MG ROVER GROUP

SERVICE ACTION BULLETIN

MG TF

HOOD DAMAGE DURING FOLDING – ADDITIONAL FRAME STRAPS

1

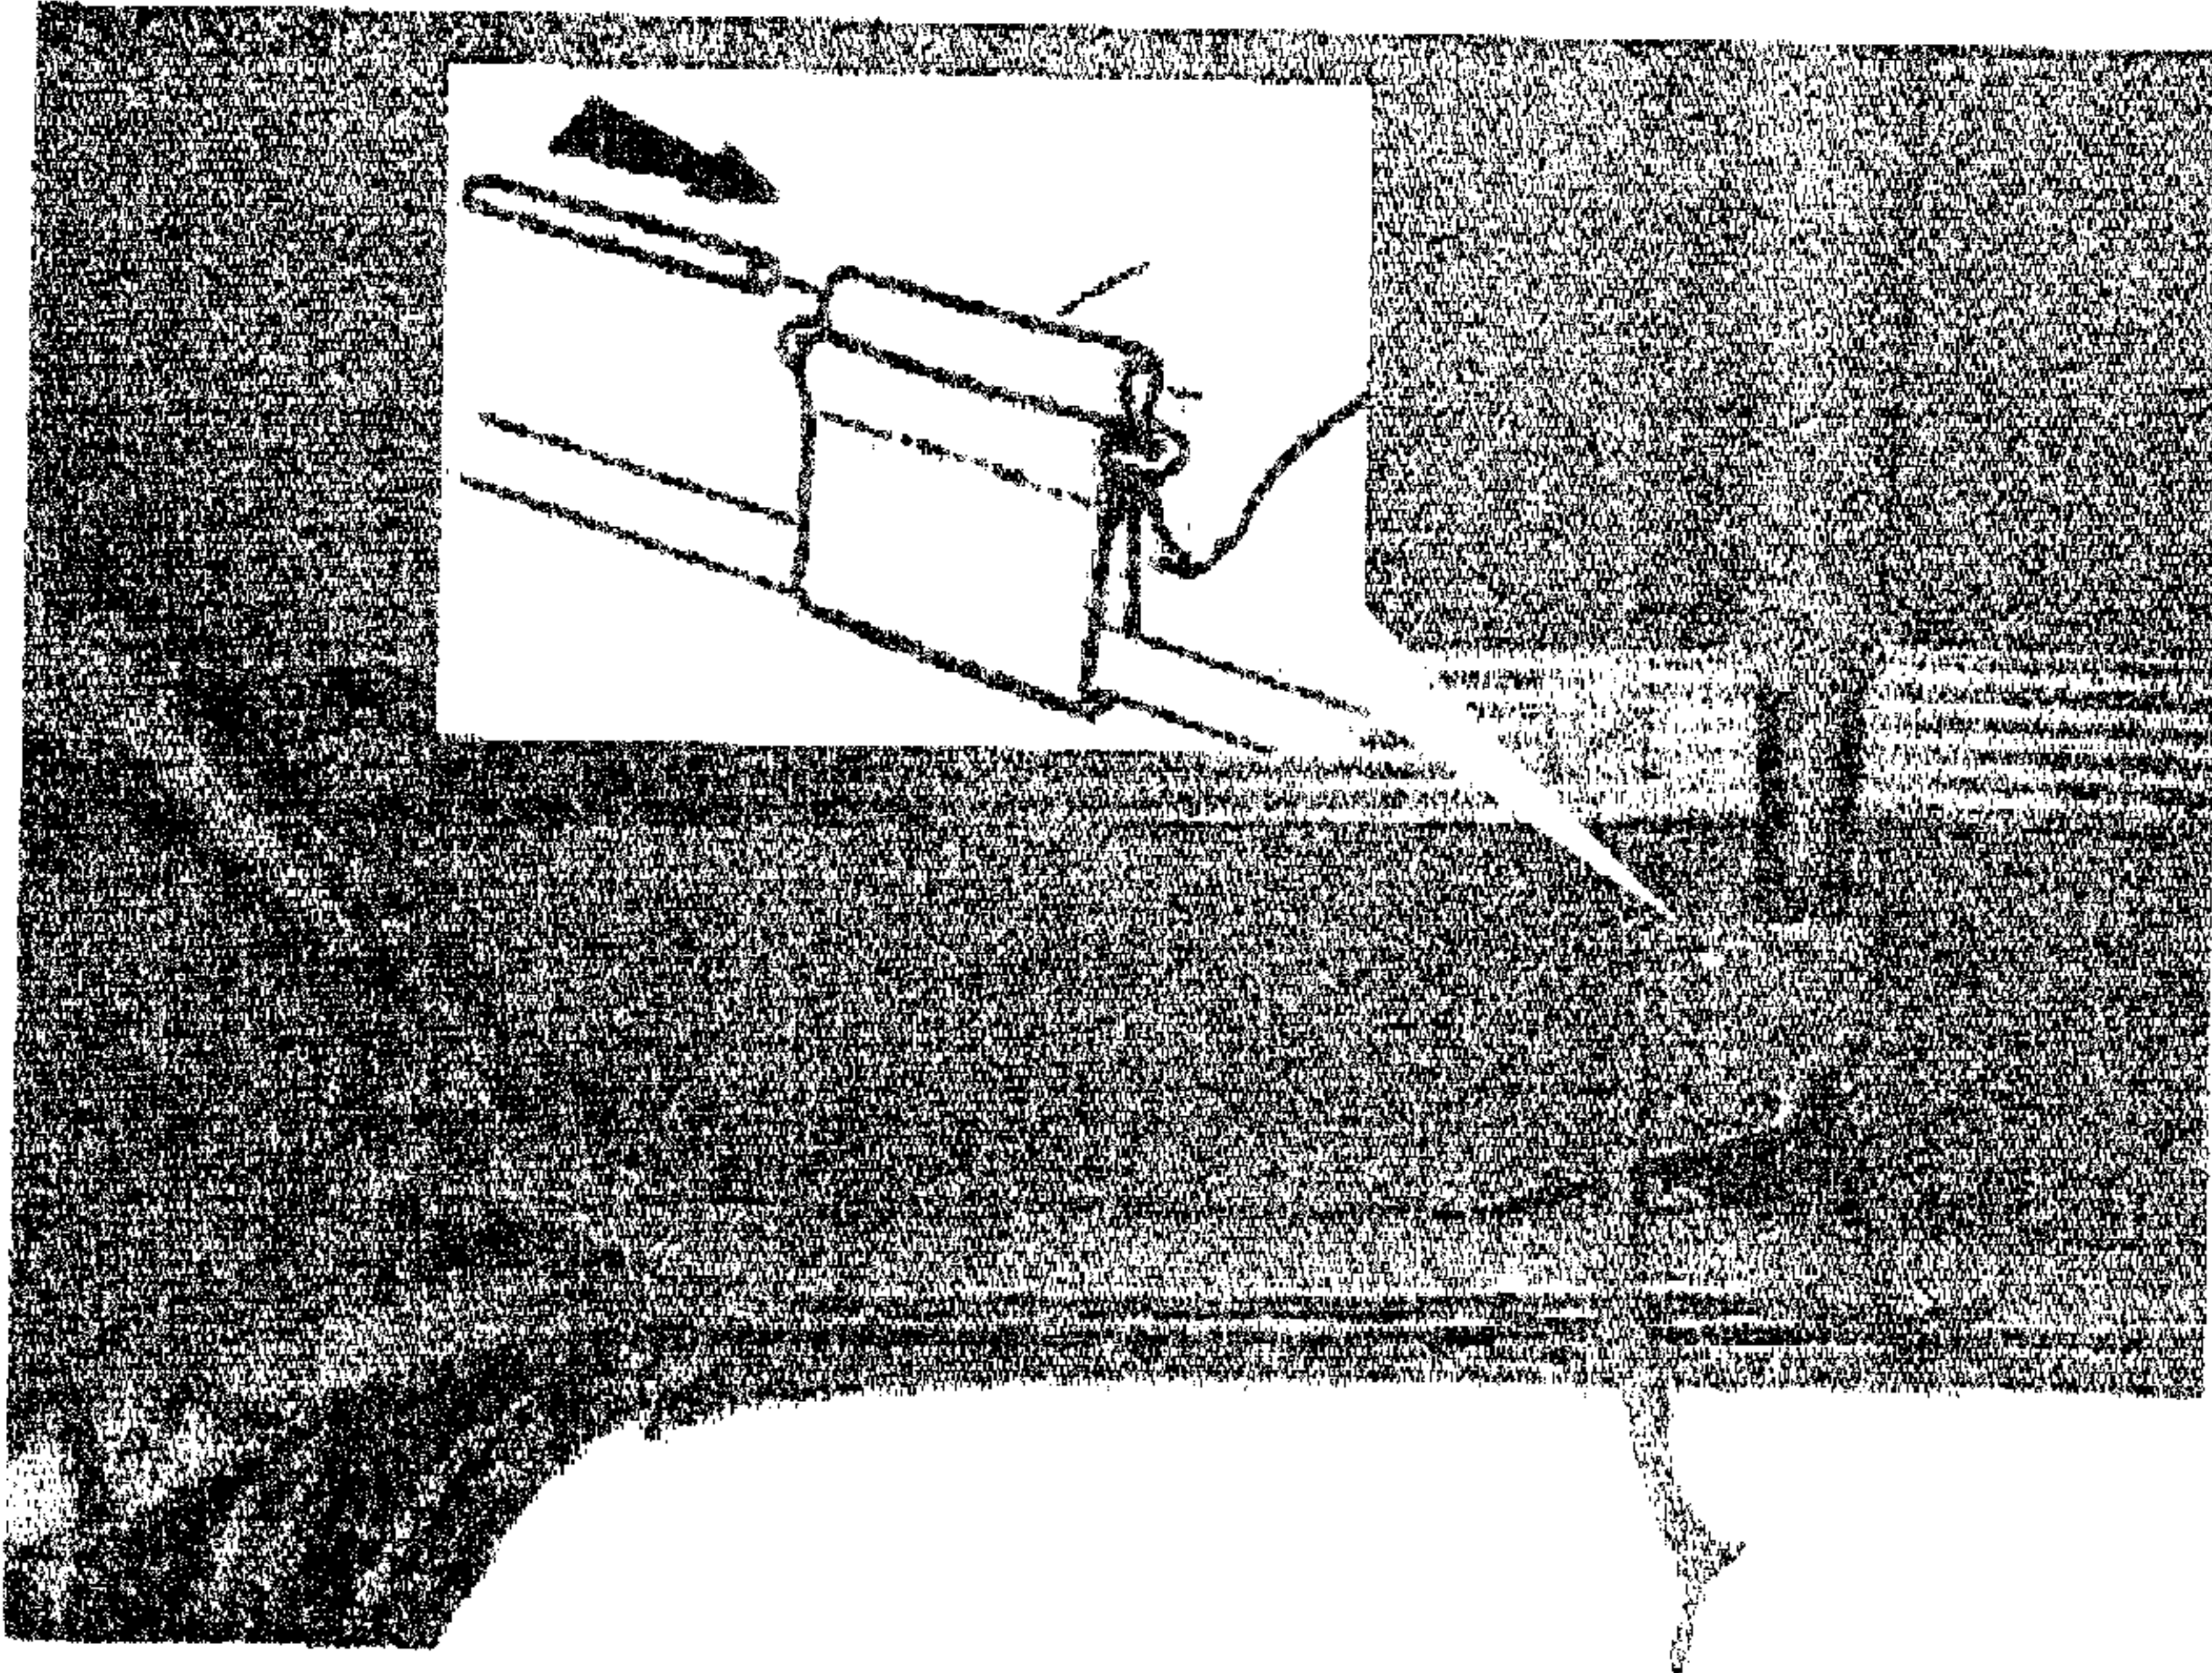
1. Lower both windows fully down.
2. With reference to illustration 1 and the hood in the raised position, fit strap to 1st frame rail ensuring that the strap buckle with fastening pin faces the front of vehicle. The strap must be positioned between the existing hood strap and the hood side levers as shown.

Attaching straps to rail: Remove pin from its stitched pocket and feed the buckle end of strap over the rail to form a loop. Feed the empty pin pocket through the buckle and re-insert the pin into pocket, the strap will now be secured to the rail. When fitted, the strap buckle must face the inside of vehicle (not facing the hood material).
